- **Planning Inspectorate Reference:** APP/Z3825/W/25/3362988
- **Horsham District Council Reference:** DC/24/0941
- **Name of Appellant(s):** Mr & Mrs Brent Dowson
- **Description of Application:** Demolition of Waterside House and rear barn. Erection of replacement building to provide 10 no residential apartments

Site at: Waterside House, 17 Lower Street, Pulborough, West Sussex, RH20 2BH

Objection to Planning Application Ref: DC/24/0941

Figure 4: Proposed new building footprint vs existing building footprint (dotted line)

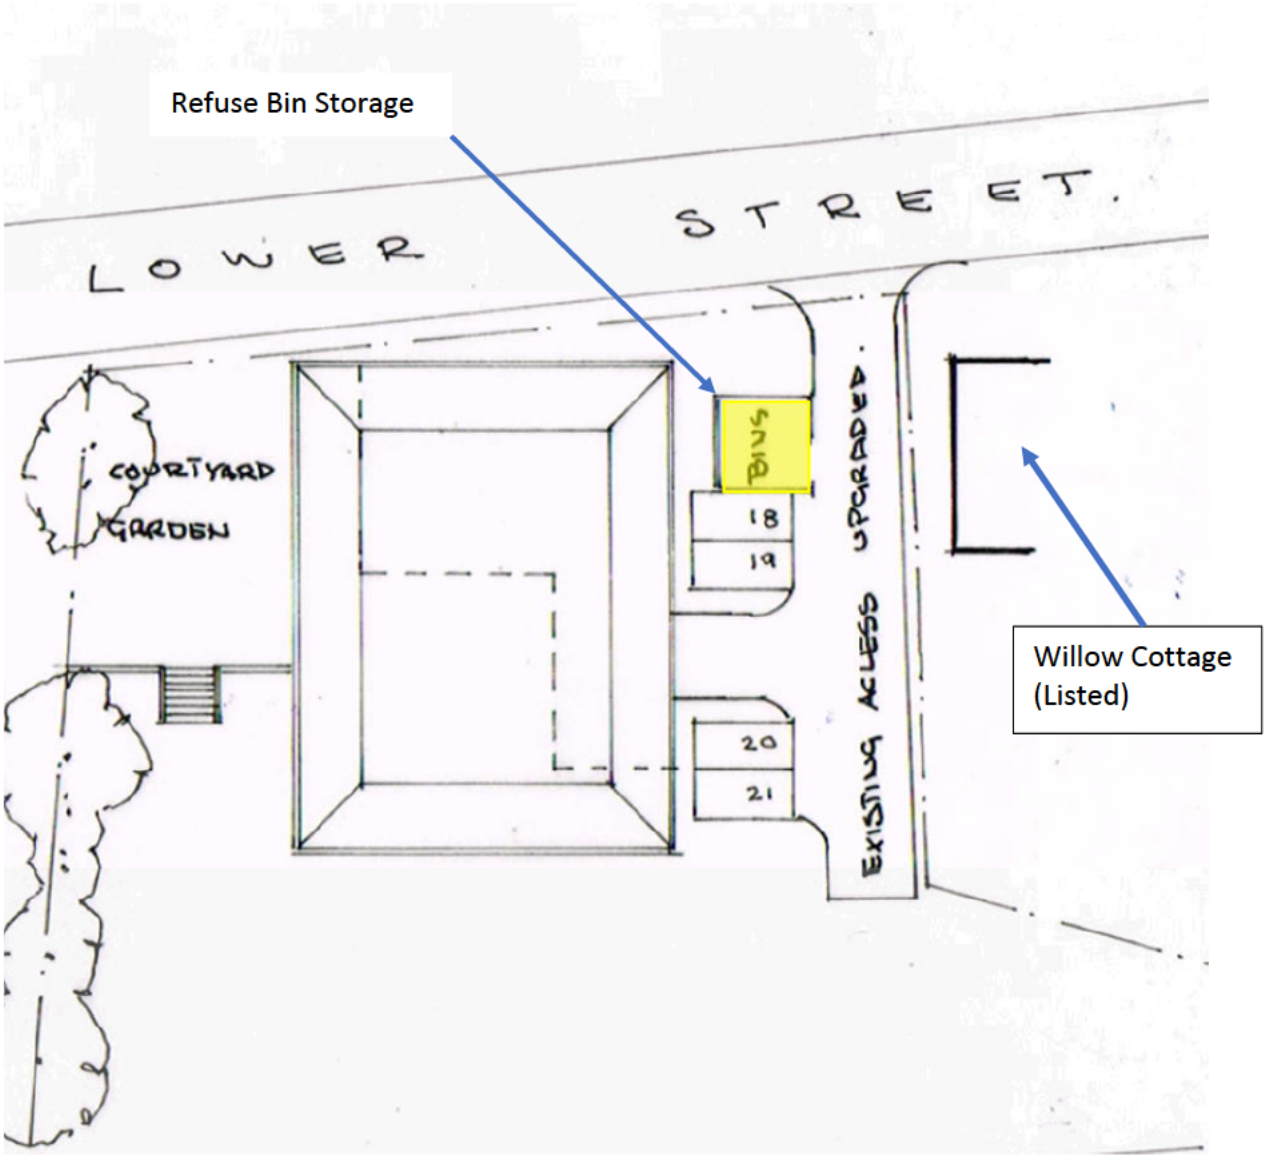
The significant increase in the size and massing of the proposed 10 apartment building does not meet the requirements of the Pulborough Conservation area. It appears the size (floorplan square footage) for the proposed development would increase by at least 300% Specifically:

- The southerly extension at three stories materially reduces views through the site and onto the South Downs National Park AONB
- The southerly extension at three stories negatively impacts views into the Pulborough Conservation area from the South Downs National Park AONB (views into the Conservation area are a stated consideration for the area)

- The amenity of listed Willow cottage will be significantly impacted due to the extended height and length of the proposed building. It will dominate the view, in direct conflict with the Conservation Area requirements.

- The addition four carparks (numbered 18-21 in Figure 4) and din store detract from the amenity of listed Willow Cottage
- Refuse Bins:
    - The application proposes a location for bins next to the external car parks, opposite to and in direct line of site of the listed Willow Cottage.

- If individual bins are used:
        - 30 bins (3 bins per household (1x waste, 1x recycling, 1x green/garden waste) x 10 houses) would need to located in the marked area on Figure 4. The size of the bin area does not appear to support this many bins. This would be significant visual detraction and impact to views of and through the site

Image 9 – Fluvial flood levels – Appendix C, Nijhuis Industries Report

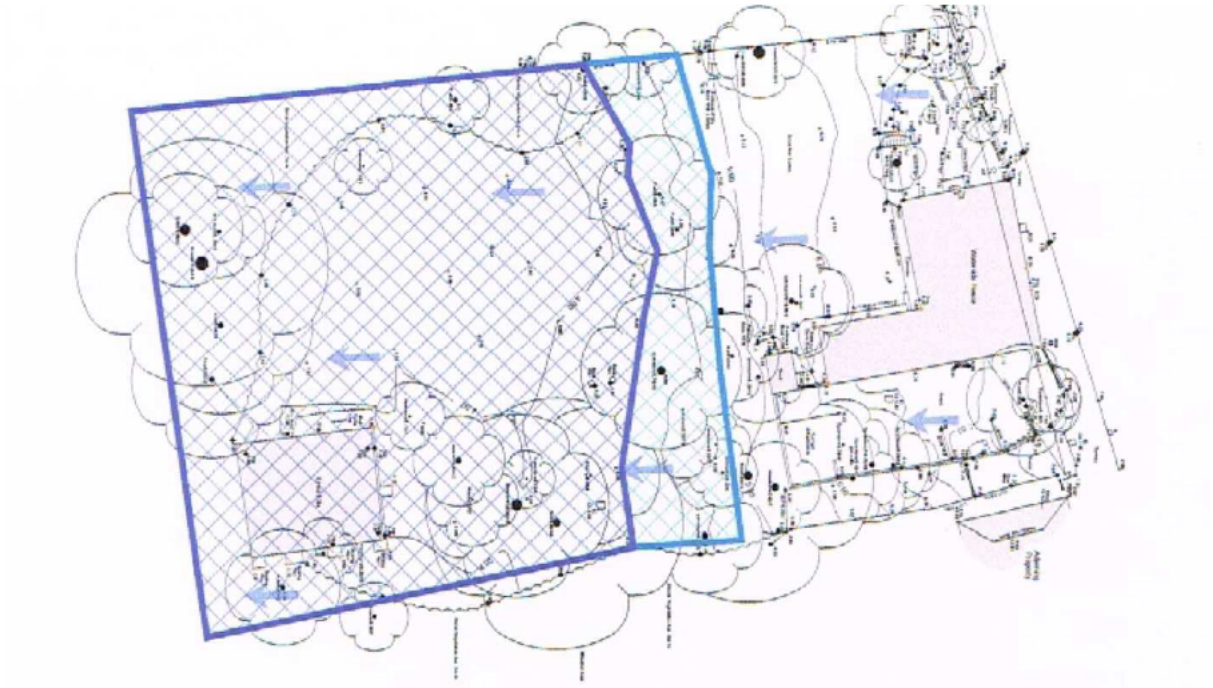
The views of and through the Conservation Area, including to & from the South Downs National Park AONB will be materially worsened when looking upon flooded dwellings, flood isolated buildings and access structures. The southerly extension of the proposed 10 apartment building will bring it very close to fluvial flood levels (*per Image 9)*.

- Presumably the system would be located on the lower part of the property, which is exposed to flooding per Images 7, 8 & 9. How would this system be protected from flood waters?
- How would the system be sized to manage the flood water shown in Images 7, 8 & 9?

Image 10 – Section 3.5 from Nijhuis report

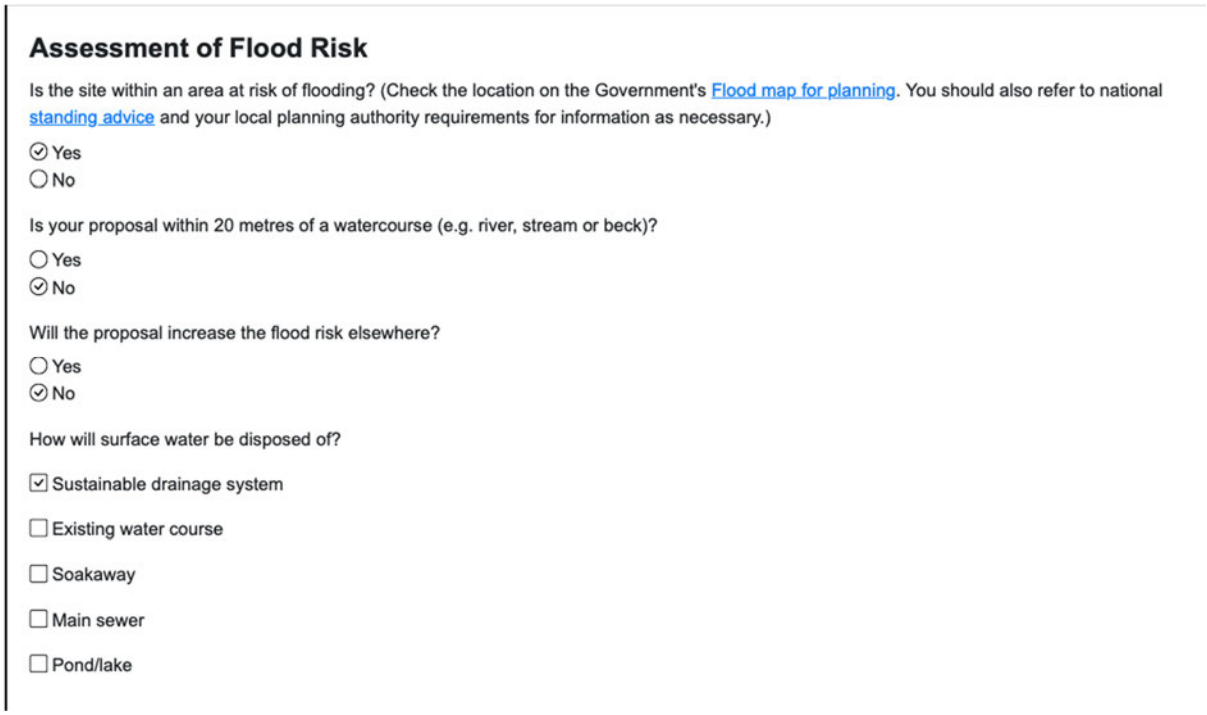
The application makes no provision for:

- surface water arising from the development
- provide any details of a suitable water drainage system
- provide any details for compensatory flood water storage

As water solutions specialists, why have they not proposed solutions to mitigate these requirements? The logical conclusion is that a viable solution does not exist or is excessively costly.

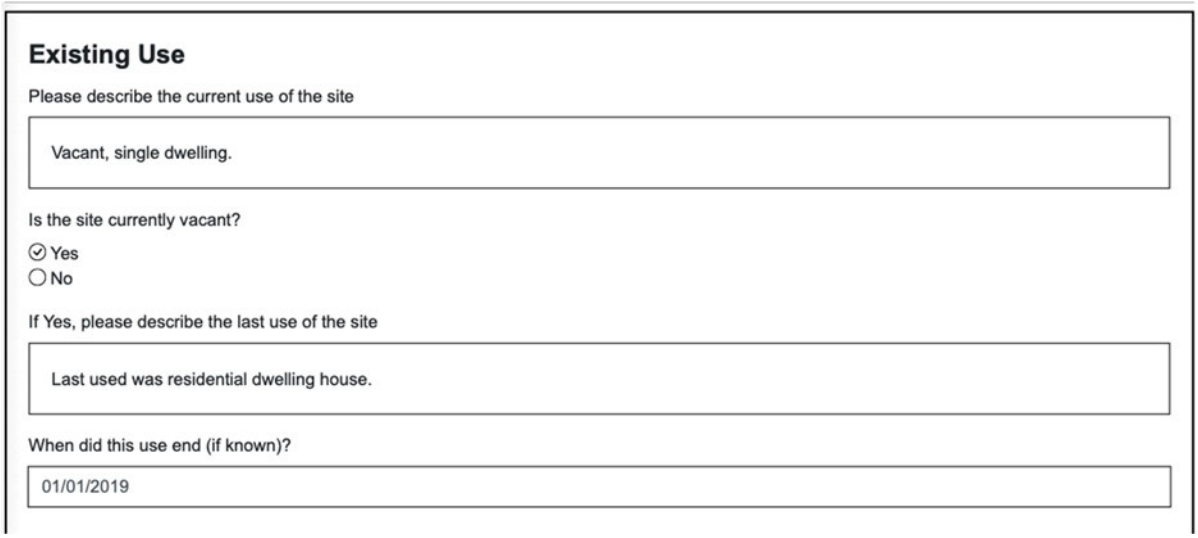
Refusal of a previous Planning Application DC/11/0805 (erection of 1x 4 bedroom dwelling) at Waterside House included a specific objection from WSCC and PPC due to risks associated with access and egress from the site and it's proximity to a bend.

"Reason: The increased use of the existing access to the public highway would add to the hazards of highway users to an unacceptable degree."

Having established the public highways risks relating to ingress and egress from the site and proximity to a bend, parking of either visitor or resident vehicles on Lower Street and making it a de facto car park cannot be acceptable. In addition to the public highways risk, parking on Lower Street would not meet the Conservation Area requirements as it would detract from views within and through the area, and materially negatively impact the amenity of the nearby listed buildings.
